Re: Geary BRT Project Environmental
Re-evaluation

Subject: Submittal of Checklist for Geary Bus Rapid Transit Re-Evaluation

Geary Bus Rapid Transit Re-Evaluation

Project Title: Geary Corridor Bus Rapid Transit Project

Figure 1 Geary/Masonic Bus Shelter

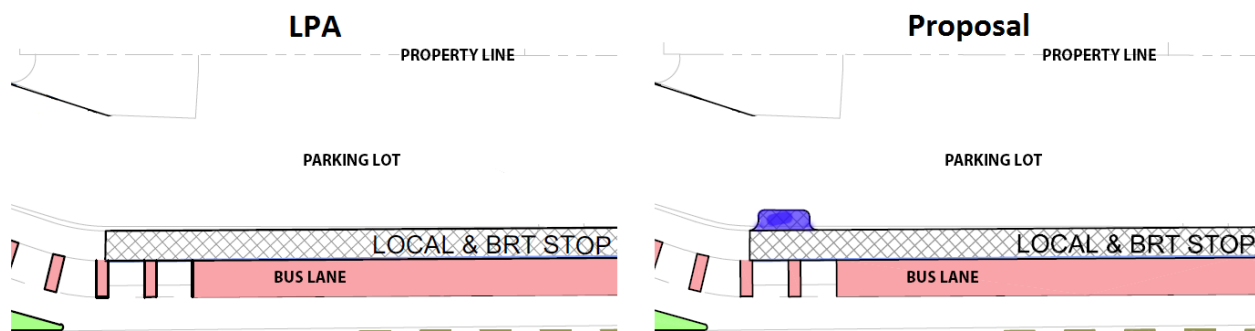
The Hybrid Alternative/LPA design at the outbound Masonic Avenue bus stop provided only the existing sidewalk footprint for bus stop amenities, such as a bus shelter. The revised design extends the existing sidewalk at the Geary/Masonic outbound bus stop to the north into an adjacent SFMTA-owned public parking lot to create additional space to relocate the bus shelter. The sidewalk expansion would be approximately 7 feet wide (into the parking lot) and 17 feet long (parallel to the roadway). The bus shelter would be relocated north from the location proposed in the FEIS to a location within the expanded sidewalk. This expansion provides more space for pedestrians to walk and to wait for the bus. This change is shown in **Figure 1**.

Figure 2 Representative Examples of Bus Stop Shortening (left) and BRT/ Local Stop Consolidation (right)

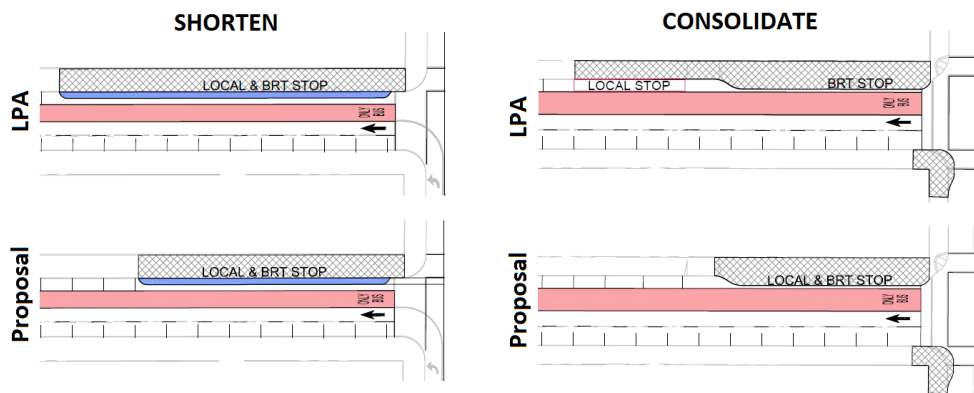
The Hybrid Alternative/LPA included bus stops long enough for three 60-foot articulated buses at most of the stops served by both BRT and local service. At some of these stops, the Hybrid Alternative/LPA also anticipated separate places for the local and BRT services to stop within one bus stop area. **Figure 2** shows these typical configurations in the top row (labeled 'LPA'). The individual bus stop designs analyzed in the FEIS can be found in Appendix A of the FEIS. SFMTA proposes to shorten each stop served by BRT and local buses to accommodate two buses instead of three buses. At stops where separate places were previously proposed for BRT and local buses to stop, SFMTA proposes to consolidate the stops for the local and BRT bus services at a single point. **Figure 2** depicts both of these types of changes. These changes are proposed to improve transit performance and passenger experience as further described in the analysis below.

In areas where the length of the bus stop is shortened, a shorter bus bulb would be constructed. Since the precise length of each bus stop as proposed in the FEIS under the Hybrid Alternative/LPA varies, the reduction necessary to achieve a length of approximately 120 feet (sufficient to accommodate two buses) also varies by stop but is generally between 20 and 60 feet. In some cases, bus stop shortening preserves additional parking and loading as described below. The type of bus stop described in the FEIS would remain unchanged (i.e. Shelter Plus or Signature).

Figure 3 **Geary: Polk to Van Ness Traffic Striping**

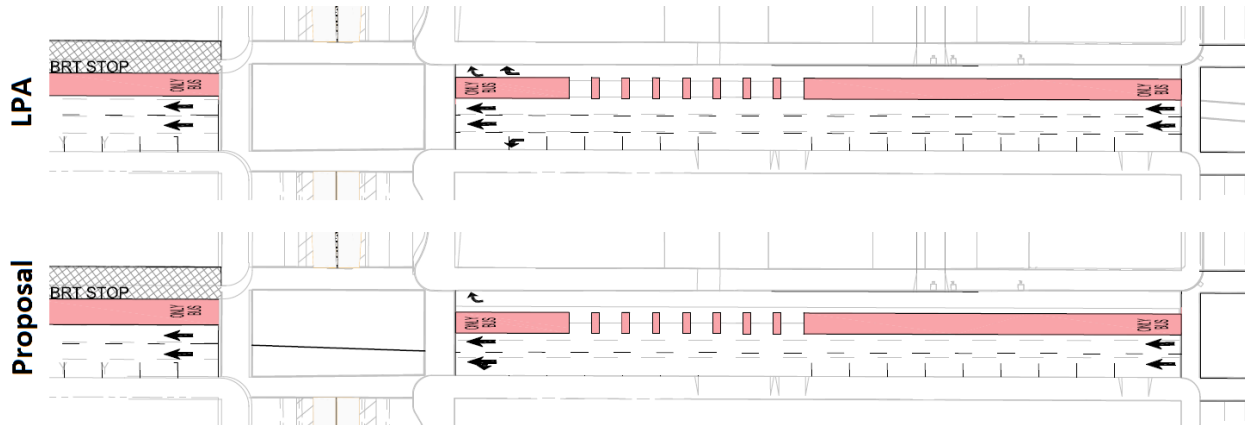
SFMTA proposes to maintain the existing roadway and sidewalk widths and restripe the existing four outbound lanes to provide the following configuration: one peak-hour tow-away shared left turn/through lane, one general mixed-flow through lane, one bus-only lane, and one right-turn lane, for a total of four lanes. This configuration would match the lane configurations on the blocks immediately east and west of this block.

This change would result in the loss of six parking spaces to provide more capacity for westbound left-turn movements outside of the peak-hour tow-away time periods. The change to the street configuration for Geary Street between Polk Street and Van Ness Avenue is shown in **Figure 3**.

Figure 4 Laguna Stops

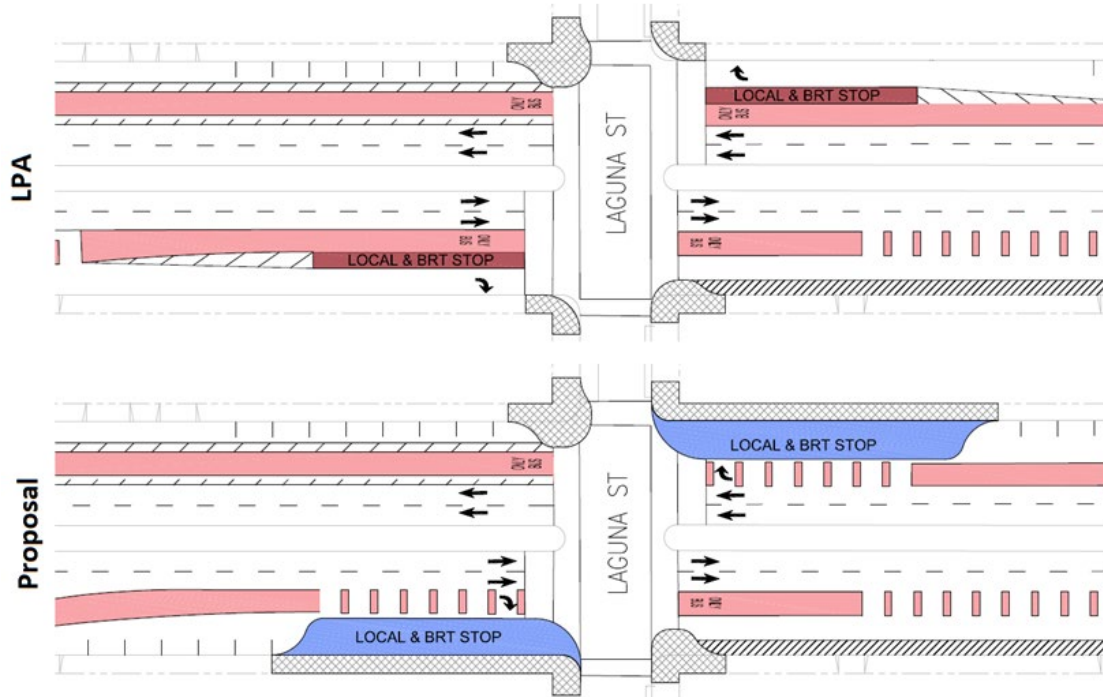
SFMTA now proposes to construct bus bulbs in place of transit islands along both the inbound and outbound approaches. The bus bulbs would be approximately 20 feet wide by 130 feet long, and create additional sidewalk space compared to the Hybrid Alternative/LPA.

Construction of bus bulbs in place of transit islands would result in a shared right-turn and bus-only lane at each bulb. This change would afford larger trucks the opportunity to make legal right-turns onto Laguna Street. In addition, this change responds to stakeholder input expressing a preference for bulbs instead of islands. The changes at the Geary/Laguna stops are shown in **Figure 4**.

Constructing bus bulbs and not transit islands would require the removal of five existing parking spaces where the sidewalk would be extended. However, the bus bulbs would preserve seven parking spaces previously assumed to be removed along Geary at the northeast and southwest approaches necessary to accommodate boarding islands, as shown in **Figure 4**.

Figure 5 **Geary/Webster Modified Traffic Patterns**

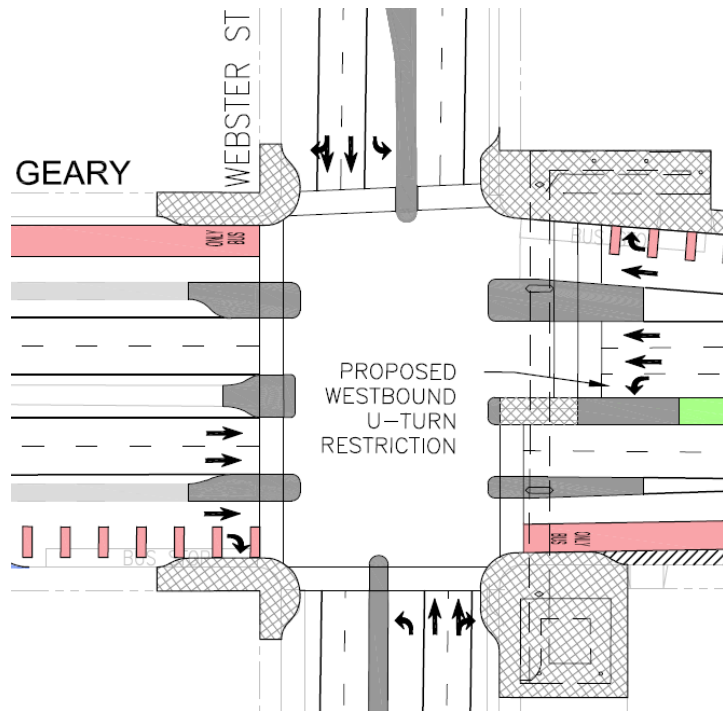
SFMTA proposes to restrict U-turns at this location, requiring additional signage on-site to regulate traffic. This change would allow pedestrians to cross the southern half of the crosswalk while westbound traffic has a green signal for left hand turns. The Geary/Webster U-turn restriction is shown in **Figure 5**.

Figure 6 Hybrid Alternative/LPA Turning Movements

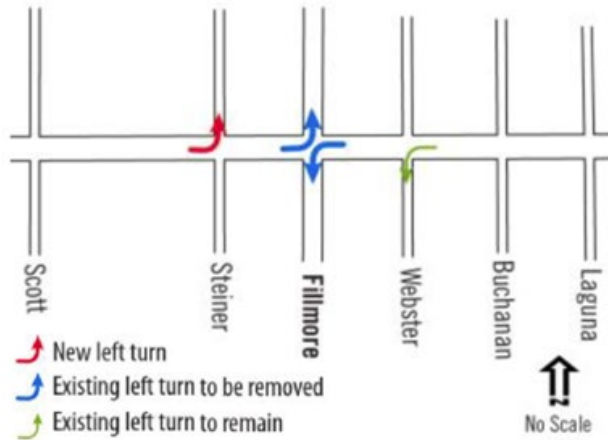
The Hybrid Alternative/LPA will alter existing traffic patterns by restricting eastbound and westbound left turns at the Geary/Fillmore intersection. The Hybrid Alternative/LPA also included installation of a new eastbound left turn lane and reconfiguration of the median at the Geary/Steiner intersection. The allowed turning movements in the Hybrid Alternative/LPA are shown in **Figure 6**.

Figure 7 Geary/Steiner Intersection

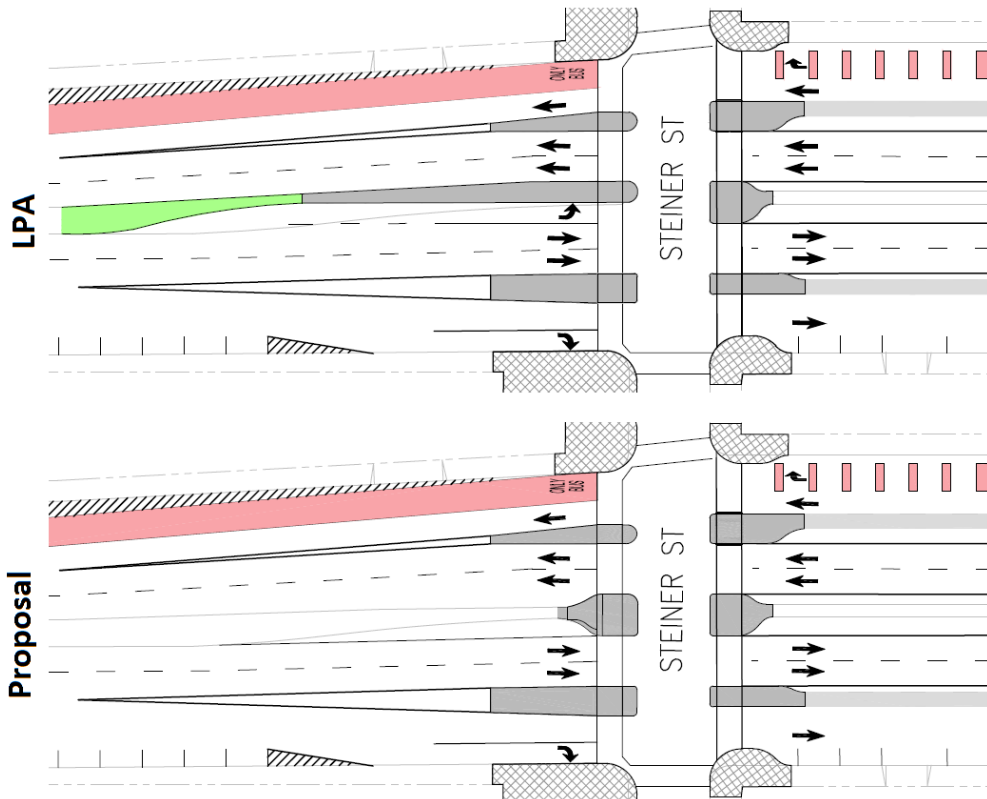
SFMTA proposes to maintain the existing eastbound and westbound left turns at the Geary/Fillmore intersection, and continue restricting left turns in the eastbound direction at the Geary/Steiner intersection.

To restrict eastbound left turns at Geary/Steiner, the center median pedestrian refuge island in the west side crosswalk would be expanded. The median refuge island would be widened by about 10 feet compared to the Hybrid Alternative/LPA, as shown in **Figure 7**.
